Audit Report

California Bridge Seismic Retrofit Program

Report Number: R9-FH-7-002

Subject: **ACTION:** Report on Audit of California
Bridge Seismic Retrofit Program
Report Number R9-FH-7-002

Shotcrete Cores Showing Shadows and Cracks

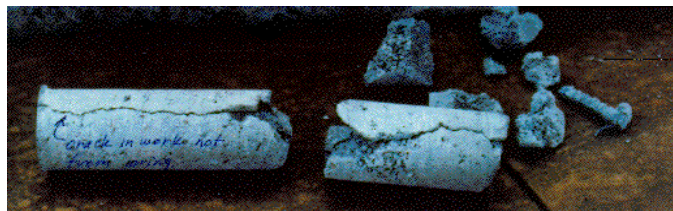
Also, shotcrete sampling and testing were insufficient or non-existent. For one project we visited, the Caltrans engineer tested the shotcrete for compressive strength by casting cylinders from the back of the delivery truck. A preferred method for testing shotcrete is to use test panels and extract production cores adjacent to steel bars. On another project we reviewed, the Caltrans engineer waived all pre-construction and production testing because he had been satisfied with the work of the contractor on a previous project. However, this engineer did not have formal training in inspecting shotcrete work.

Further, for two other projects reviewed the shotcrete applications were defective, and the contractors were required to repair or replace the shotcrete. Voids in shotcrete work at the Los Angeles River Bridge were repaired with pressurized grouting methods. For one span of the Petaluma bridge, the Caltrans engineer rejected shotcrete in all 16 bolsters because the materials did not bond to the reinforcing steel bars in the bolsters. On another span of the Petaluma bridge, the Caltrans representative rejected 1 of 2 bolsters because of poor bonding to the reinforcing steel bars. For both spans, Caltrans required the contractor to replace the shotcrete bolsters with bolsters constructed with cast-in-place concrete. For one of the bridges, the Caltrans engineer stated:

Below are examples of defective shotcrete
